Athlone Link Road Phase 2 Athlone, Co. Westmeath

Report No. RSA ST1.2 001

Stage 1/2 Combined Road Safety Audit Report

02 June 2025

3.2.1 PROBLEM

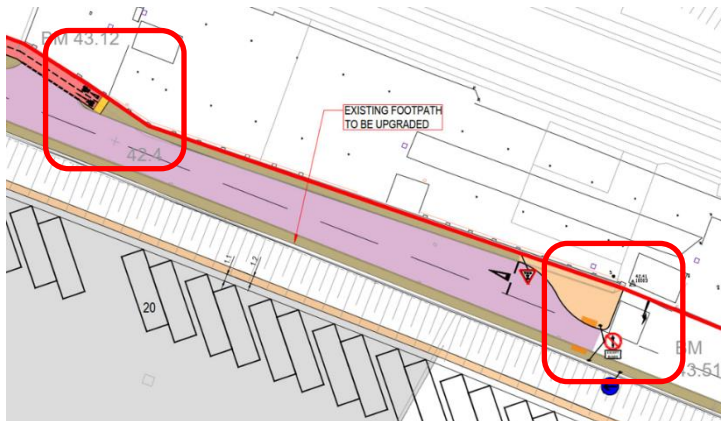
Location: Proposed cycleway on Southern Station Road.

Summary: Risk of cyclist or pedestrian fall due to insufficient wall height

Detail: A low wall (approximately 300–500 mm high) is located immediately adjacent to the proposed cycleway on the northern side of Southern Station Road. The wall is not designed to function as a barrier and does not provide any containment or edge protection. In the absence of a suitable upstand, barrier, or guardrail, there is a risk that pedestrians, particularly children or those with impaired mobility, could trip or fall over the wall. Cyclists may also misjudge the edge, leading to a loss of control or fall, particularly during darkness or inclement weather. The hazard is further exacerbated if the adjacent level difference is greater than 600 mm.

Edge protection in the form of a suitable pedestrian restraint system or cycle-friendly barrier should be provided along the length of the wall where the level difference poses a fall hazard.

Alternatively, the footway/cycleway alignment should be revised to increase the lateral offset from the wall to reduce the likelihood of user interaction. Any proposed treatment should comply with relevant standards for containment and visibility.

3.2.2 PROBLEM

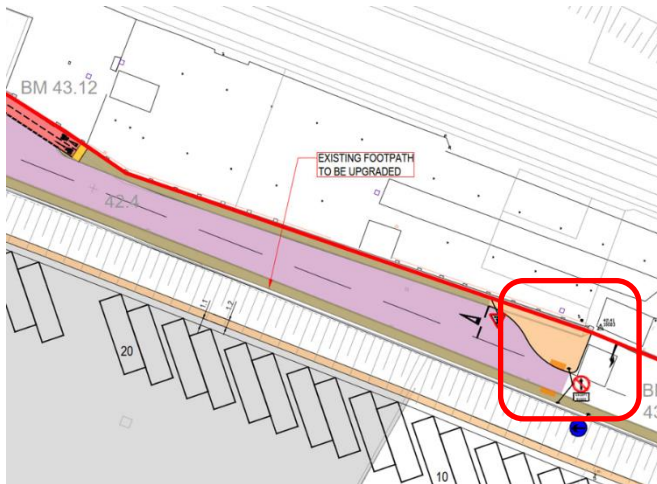
Location: Proposed cycleway on Southern Station Road.

Summary: Abrupt start/end of cycle facility with no clear direction for onward movement.

Detail: The cycle lane terminates without any signage or physical guidance to indicate the appropriate onward route for cyclists. This can result in confusion for cyclists unfamiliar with the area and may lead to unsafe manoeuvres, such as swerving into live traffic lanes or mounting

footways to continue their journey. Cyclists travelling towards Coosan Point Road are required to cross the carriageway to join the cycle lane. The absence of clear route continuity compromises cyclist safety and may discourage use of the facility.

Provide appropriate signage, road markings, or physical infrastructure be provided to clearly indicate the onward route for cyclists when the cycle lane terminates. Where a designated continuation route is not available, advance signage should inform cyclists of the lane's termination and direct them to the nearest safe alternative. Suitable facilities should be provided for cyclists to cross the carriageway when travelling towards Coosan Point Road.

3.2.3 PROBLEM

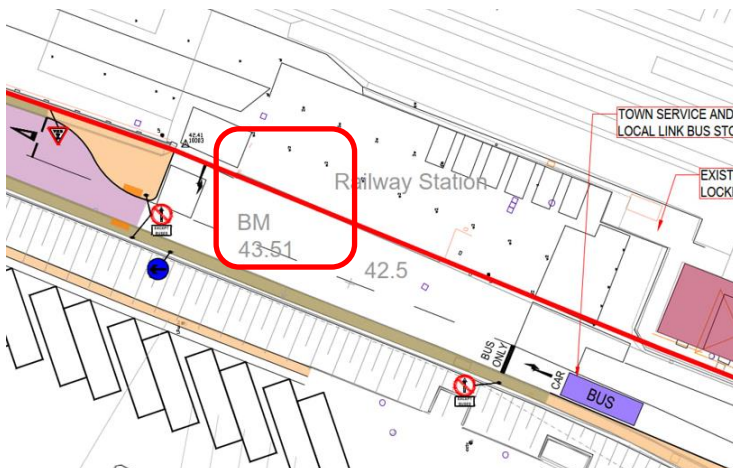
Location: Termination point of footway on Southern Station Road.

Summary: Footway ends abruptly with no formal crossing or onward pedestrian provision.

Detail: The pedestrian footway terminates suddenly at the edge of the carriageway on the eastern side, with no dropped kerb, tactile paving, crossing point, or alternative pedestrian facility provided. On the western side the footway terminates at the start/end of the proposed cycle lane. Pedestrians, including vulnerable users such as children, elderly persons, or those with impaired mobility, are forced to step directly into the live carriageway travelling eastbound, increasing the risk of conflict with passing vehicles. Travelling westbound, pedestrians may enter the cycleway, increasing the risk of conflict with oncoming cyclists.

Provide a safe and accessible pedestrian facility at the termination point of the footway at the start and end point. This may include a dropped kerb with tactile paving and a formal or uncontrolled crossing point to the opposite side of the carriageway. If a crossing is not appropriate at this location, the footway should be extended through the car park entry/exit area (existing taxi waiting area) to connect with the existing footway approaching the train station, with appropriate signage or barriers to guide pedestrian movement and discourage unsafe desire lines across the carriageway.

3.2.4 PROBLEM

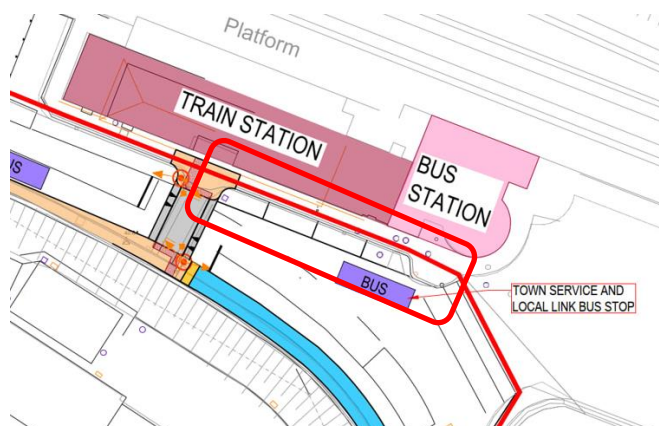
Location: Exit from train station car park to Southern Station Road.

Summary: Restricted visibility for vehicles exiting car park onto main road.

Detail: Visibility from the car park access onto the main road is restricted due to the existing boundary wall to the right on exit. Drivers exiting the car park may have insufficient visibility of approaching traffic from the right. This increases the risk of side-impact collisions as drivers may emerge without adequate awareness of oncoming vehicles, cyclists, or pedestrians.

Visibility splays should be assessed and provided in accordance with appropriate design standards. If adequate visibility cannot be achieved, consideration should be given to relocating the access point, subject to further design review. If a footway is provided through the existing access point (refer to Problem 3.2.3), this may assist in achieving an improvement to the visibility splay to the right.

3.2.5 PROBLEM

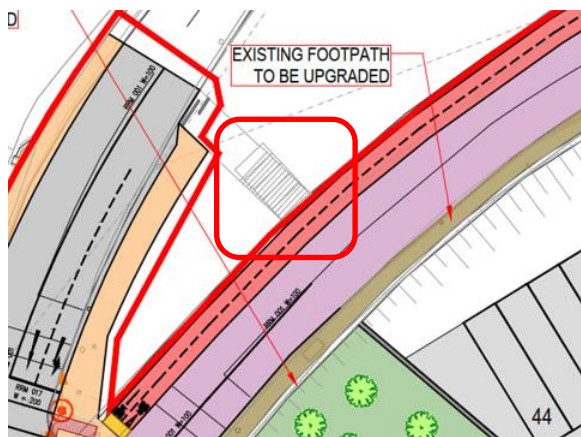
Location: Existing disabled parking bays adjacent to train station.

Summary: Removal of disabled parking bays reduces accessibility for mobility-impaired users.

Detail: The proposed scheme removes existing designated disabled parking bays without providing suitable replacement spaces of equivalent proximity or accessibility. This reduction in accessible parking provision may disproportionately affect mobility-impaired users, particularly for access to the train station. The absence of conveniently located and clearly marked accessible bays may result in mobility-impaired drivers being forced to park further away or in unsuitable locations, increasing their exposure to vehicular traffic and potentially leading to unsafe crossing or movement through the car park or carriageway.

The design should be reviewed to ensure that an adequate number of accessible parking bays are retained or provided in accordance with relevant standards (e.g. Building Regulations Part M, Inclusive Mobility guidance). Bays should be located close to key destinations with level access, sufficient space for side and rear transfer, and clear signage.

3.2.6 PROBLEM

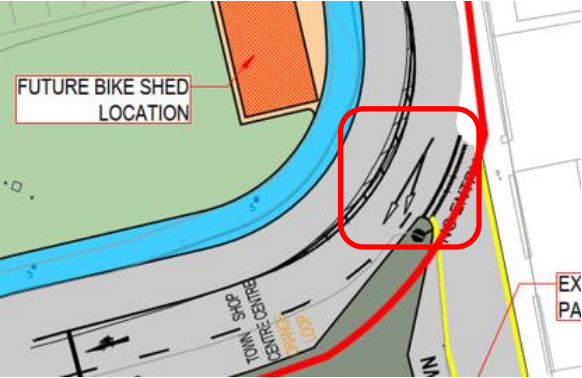
Location: Pedestrian access steps leading onto proposed cycleway at Southern Station Road.

Summary: Risk of collision or trip due to steps emerging directly onto a live cycle route.

Detail: A set of pedestrian steps leads directly onto the cycleway from Coosan Point Road without any form of buffer space, warning signage, or visibility measures. Pedestrians may emerge suddenly onto the cycle track, often at reduced visibility or speed due to the descent. Cyclists travelling along the route may be unaware of the pedestrian access and unable to react in time to avoid conflict, particularly if speeds are moderate or higher. The interface creates a risk of collision and may also pose a trip hazard if the cycleway surface is flush with or obscures the step edge. This arrangement does not align with recommended separation or transition design between pedestrian and cycling facilities.

Remove steps as there appeared to be no formal pedestrian route from Coosan Point Road to the existing steps.

3.2.7 PROBLEM

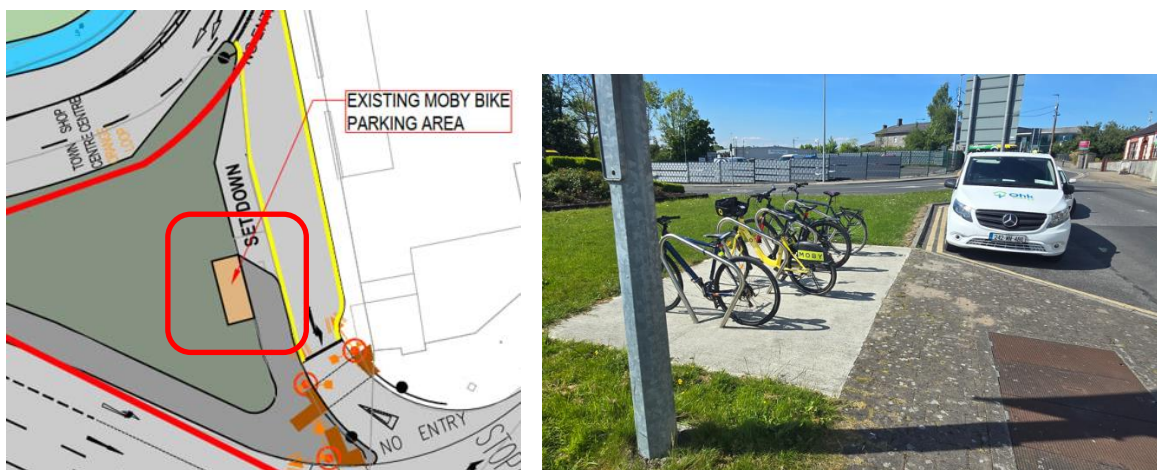
Location: Southern Station Road junction with link to Ballymahon Road.

Summary: Removal of yellow box may lead to blocking of junction and increased risk of collisions.

Detail: The proposed design removes an existing yellow box road marking at the junction of Southern Station Road and the link road to Ballymahon Road. The yellow box previously served to prevent vehicles from queuing across the junction and obstructing turning movements or cross-traffic flows. Its removal may result in vehicles entering and stopping within the junction during congestion, leading to blocked side-road access, driver frustration, and unsafe manoeuvres such as vehicles forcing gaps or entering opposing traffic lanes. This could also reduce visibility between

opposing drivers and increase the risk of side-impact collisions or pedestrian conflicts, particularly at busy intersections or during peak hours.

It is recommended that the need for yellow box markings be reviewed and retained where they are necessary to maintain junction clearance and safe turning movements. If removal is intended, justification should be provided through junction modelling and capacity analysis. Where junction blocking is still a risk, reinstatement of the yellow box or implementation of alternative junction control measures (e.g. keep-clear markings, traffic signal staging adjustments) should be considered.

3.2.8 PROBLEM

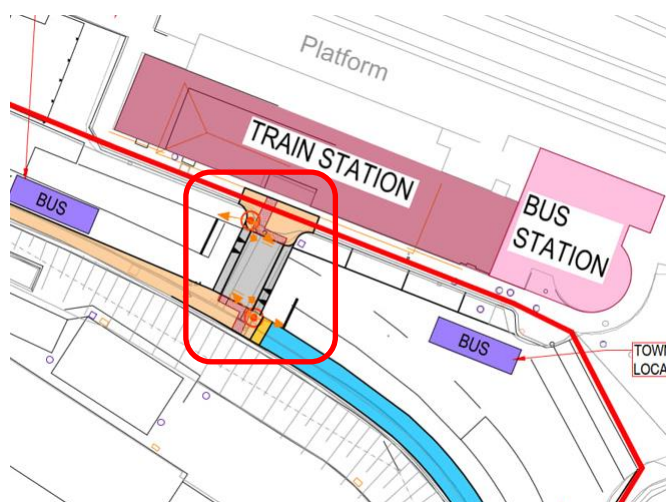
Location: Moby bike parking area on link road to Ballymahon Road from Southern Station Road.

Summary: No cycle lane or safe access route provided to serve bicycle parking area.

Detail: The existing Moby bike parking area is located adjacent to the carriageway; however, there is no dedicated cycle lane or marked access route connecting the facility to the wider cycling network. Cyclists are required to either dismount and wheel their bicycles across pedestrian areas or merge with general traffic, which may be unsuitable or intimidating for less confident cyclists. This may result in unpredictable cyclist movements, including riding on footways, conflicting with pedestrians, or errant movements through vehicle lanes. The lack of defined connectivity undermines the utility and safety of the facility and may deter use.

A clearly marked, continuous, and safe cycle access route should be provided between the bicycle parking area and the nearest cycle lane. This route should be designed to minimise conflicts with pedestrians and vehicles. Wayfinding signage and surface markings should be used to assist user understanding of the route and encourage proper use. Alternatively, relocate the Moby bike parking area to be adjacent to the proposed shared cycleway.

3.2.9 PROBLEM

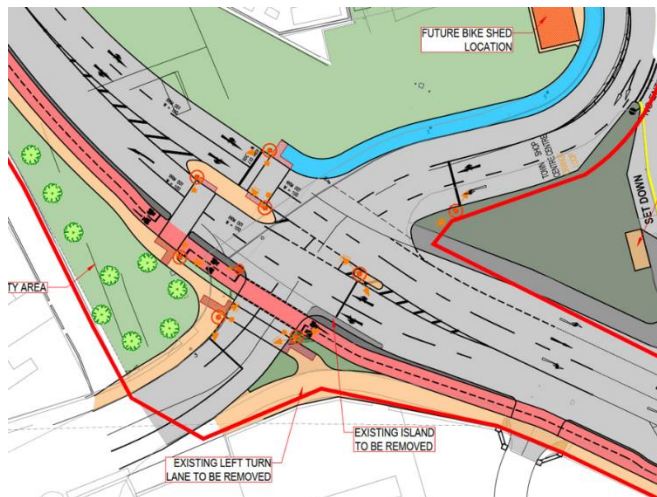
Location: Controlled crossing at train station on Southern Station Road.

Summary: Shared facility terminates without clear provision for onward cyclist movement at controlled crossing.

Detail: The shared footway/cycleway terminates abruptly at the existing controlled crossing with no defined onward route or crossing facility for cyclists. There is no dedicated cycle crossing, cyclist signal head, or guidance on whether cyclists should dismount and use the pedestrian crossing. This lack of clarity may result in inconsistent or unsafe behaviours, such as cyclists remaining mounted and weaving through pedestrian traffic or attempting to cross within the live carriageway outside of signal control. The arrangement increases the risk of conflict with pedestrians or vehicles and fails to provide a legible and continuous route for cyclists in accordance with good design practice.

The design should be revised to provide a formal and continuous crossing facility for cyclists. Options may include a parallel crossing with appropriate markings and cyclist signal heads (e.g. Toucan crossing), or clear signage and layout to indicate dismounting where appropriate.

3.3.1 PROBLEM

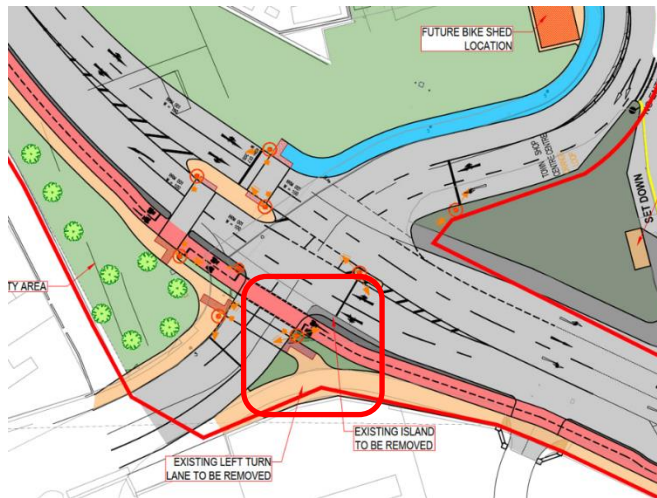
Location: Signalised junction at The Crescent / proposed link road junction with Southern Station Road.

Summary: Potential insufficient capacity at signalised junction may lead to congestion and driver frustration.

Detail: Observed queue lengths indicate that the signalised junction may not have sufficient capacity to accommodate peak hour traffic demand. This may result in extended delays, vehicles queuing beyond designated storage areas, and blocking of adjacent junctions or access points. Prolonged queuing and driver frustration can increase the likelihood of risky manoeuvres, such as vehicles entering the junction on a red signal, sudden lane changes, or mounting footways to bypass queues. Congestion at the junction may also impact pedestrian and cyclist safety, particularly where crossings are located near conflict points or blocked by stationary vehicles.

It is recommended that the junction capacity be assessed using updated traffic flow data, and signal timings or staging be optimised to improve throughput. Consideration should also be given to junction layout adjustments (e.g. additional turning lanes, extended storage lengths). If capacity constraints cannot be resolved through layout changes, measures to manage traffic demand or encourage modal shift should be explored.

3.3.2 PROBLEM

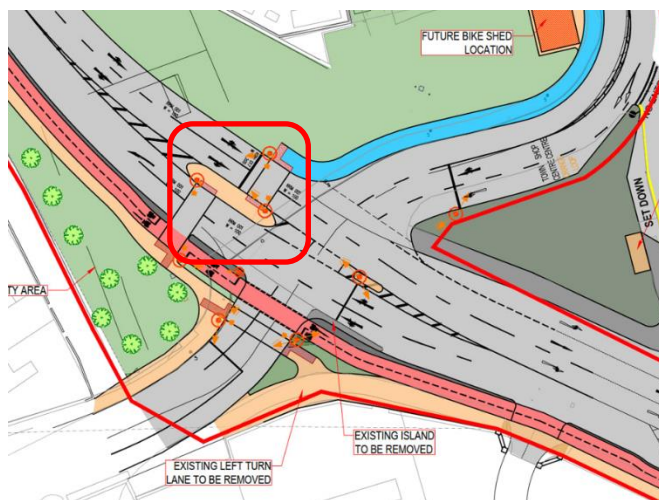
Location: The Crescent junction.

Summary: Insufficient junction corner radius may restrict HGV manoeuvres, leading to safety risks.

Detail: The junction design incorporates a tight corner radius that appears insufficient to accommodate the swept path of large vehicles, such as HGVs or refuse vehicles, turning into or out of the side road. As a result, HGVs may be required to encroach into opposing traffic lanes or mount footways to complete turning movements, creating a risk of side-swipe collisions, conflicts with oncoming traffic, or danger to pedestrians. The current layout may also result in kerb overruns, structural damage to footways, and increased maintenance needs.

A swept path analysis should be carried out for the largest design vehicle expected to use the junction. The corner radii should be adjusted as necessary to ensure safe and efficient HGV movements without encroaching onto pedestrian areas or into opposing lanes. If widening is constrained, alternative mitigation such as overrun strips or HGV-friendly kerb arrangements may be considered.

3.3.3 PROBLEM

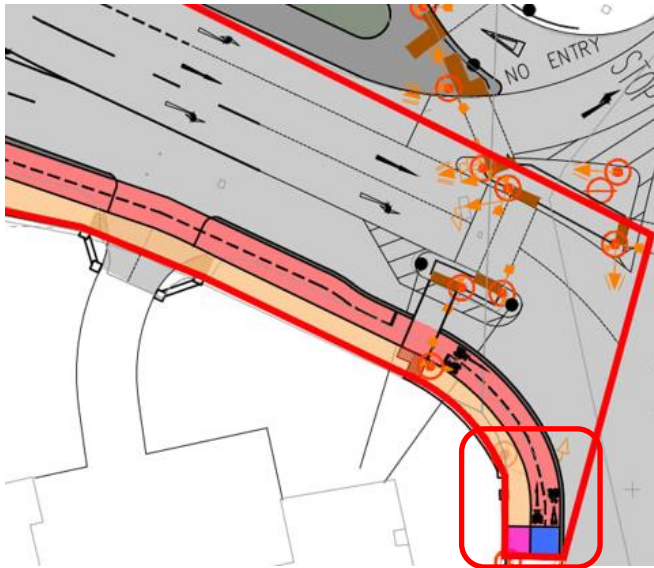
Location: Splitter island at the Crescent junction.

Summary: Potential insufficient width of central refuge creates safety and usability issues for cyclists.

Detail: The central refuge area forming part of a staggered signal-controlled crossing may be of insufficient width to safely accommodate cyclists waiting to complete the crossing manoeuvre. The refuge appears to be designed primarily for pedestrians and does not allow adequate space for a

bicycle to remain fully within the island without encroaching into the adjacent traffic lanes or obstructing pedestrian flows. This presents a safety risk to cyclists who may feel pressured to complete the crossing in a single stage or may encroach onto live traffic lanes while waiting, particularly in groups or when accompanied by cargo bikes or adapted cycles. The lack of sufficient standing space also undermines compliance with staged signal timings and increases the risk of conflict between pedestrians and cyclists.

It is recommended that the central refuge island be widened to provide adequate waiting space for cyclists in accordance with relevant standards, including the accommodation of larger or non-standard cycles. The design should ensure cyclists can wait safely without obstructing pedestrian movement or entering live traffic lanes. Alternatively, if widening is not feasible, the crossing should be redesigned to allow single-stage crossing for cyclists, or a separate parallel crossing provided to improve flow and safety for all users.

3.3.4 PROBLEM

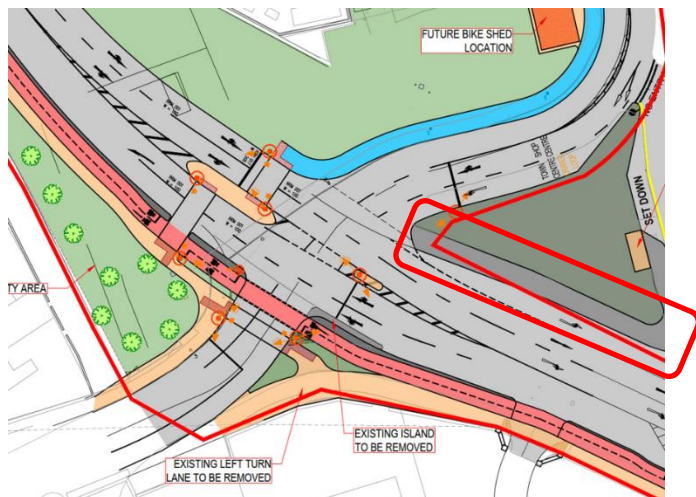
Location: Start / end of proposed cycleway at Gleeson Street junction with The Crescent.

Summary: Unclear start and end of cycle lane in footway area creates confusion and risk of conflict.

Detail: The cycle lane begins and terminates within a pedestrian footway area without clear delineation, signage, or transition markings to guide cyclist and pedestrian movements. The absence of defined start and end points results in a lack of clarity regarding cyclist priority, direction of travel, or expected behaviour at the interface. This may lead to conflicts between pedestrians and cyclists and increases the risk of collisions or near misses. The arrangement may also cause uncertainty for visually impaired users, as tactile guidance is not continuous or clearly aligned with cycle movements.

Clear and continuous delineation should be provided at the start and end of the cycle lane within the footway area. This should include surface markings, contrasting surfacing, and vertical or tactile separation as appropriate. Wayfinding signage and on-surface symbols should be used to reinforce user expectations. Where shared space is unavoidable, adequate width and sightlines should be maintained, and conflict minimisation measures introduced to promote safe coexistence of pedestrians and cyclists.

3.3.5 PROBLEM

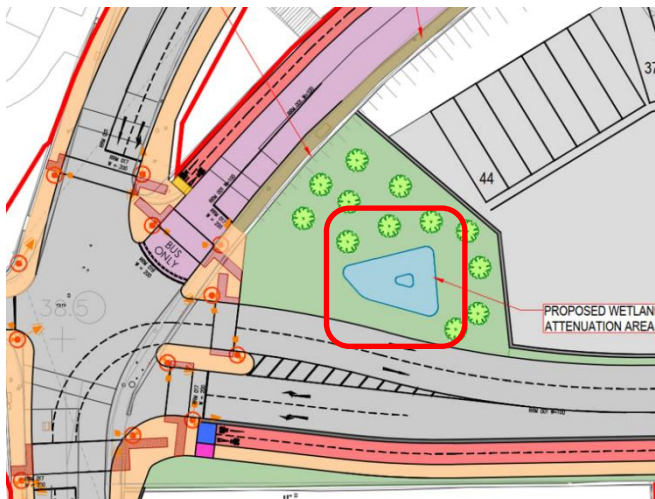
Location: Footway on northern side of The Crescent junction.

Summary: The footway leads directly to a junction without any formal pedestrian crossing facility, creating a safety risk due to informal and potentially hazardous crossing movements.

Detail: Pedestrians approaching the junction with Southern Station Road along The Crescent (travelling west) via the footway are not provided with any designated crossing facility. As a result, pedestrians – including vulnerable users such as children, older people, and mobility-impaired individuals – may be required to cross multiple traffic lanes informally, often between moving or waiting vehicles. This can lead to unsafe crossing behaviour, increased exposure time on the carriageway, and a heightened risk of pedestrian-vehicle conflict, particularly during peak traffic periods or low visibility conditions.

A controlled crossing facility should be provided at the junction on Southern Station Road. The facility should align with pedestrian desire lines. Alternatively, the footway should be removed.

3.4.1 PROBLEM

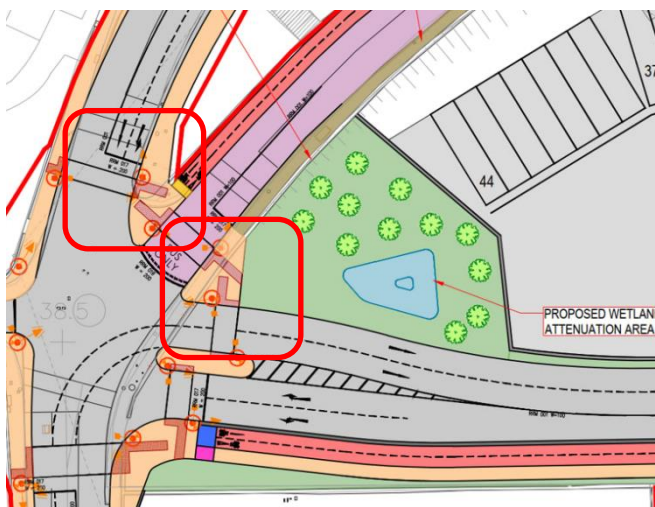
Location: Proposed wetlands area at western end of proposed link road.

Summary: Proximity of proposed wetlands to road may increase risk of vehicle incursion and water-related hazards.

Detail: The proposed scheme includes the creation of a wetlands area located immediately adjacent to the carriageway, separated only by a verge or shallow embankment with no physical restraint or containment feature indicated. In the event of vehicle loss of control, particularly in poor weather or during evasive manoeuvres, there is a risk that a vehicle may leave the carriageway and enter the wetlands, potentially resulting in occupant injury or vehicle submersion. The presence of standing or slow-moving water also increases the risk of hydroplaning due to water splash or runoff onto the carriageway. Additionally, there may be safety concerns related to maintenance access and unauthorised pedestrian entry into the wetlands from the road edge.

It is recommended that a suitable containment system (e.g. vehicle restraint barrier) be provided between the carriageway and the wetlands area, particularly where the verge width or embankment gradient is insufficient to prevent vehicle overrun. Drainage design should ensure runoff from the wetlands does not compromise road surface conditions. Consideration should also be given to fencing or low-profile barriers to deter pedestrian access from the carriageway and to maintain road user safety.

3.4.2 PROBLEM

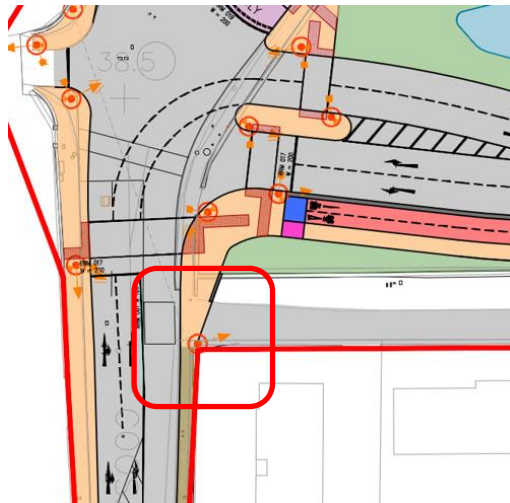
Location: Right-turning movement for bus at junction with Southern Station Road and Coosan Point Road and left turn for bus to proposed link road from Southern Station Road.

Summary: Inadequate swept path provision for bus may result in vehicle conflict and overrun.

Detail: The junction layout does not appear to adequately accommodate the swept path of a standard or articulated bus making a right or left turn manoeuvre. A bus may encroach into adjacent lanes, opposing traffic lanes, or mount kerbs and footways while completing the turn. This creates a risk of conflict with oncoming vehicles, stationary traffic, or pedestrians at the kerb edge. Repeated overrunning of the kerb may also damage footway surfaces and increase maintenance requirements.

It is recommended that swept path analysis be carried out using appropriate design vehicles (e.g. 12m rigid or 18m articulated bus) to verify the adequacy of the junction geometry. If the current layout does not accommodate bus movements safely, revisions should be made to widen the turning radius, adjust kerb lines, or provide additional lane width. The revised design should ensure that buses can turn without entering opposing lanes or over-running pedestrian areas.

3.4.1	YES	YES		
3.4.2	YES	NO	Coosan Point Road north of this junction has a low bridge which restricts the size of vehicles making these manoeuvres. The proposed junction layout does not alter the swept path from existing for these movements.	YES
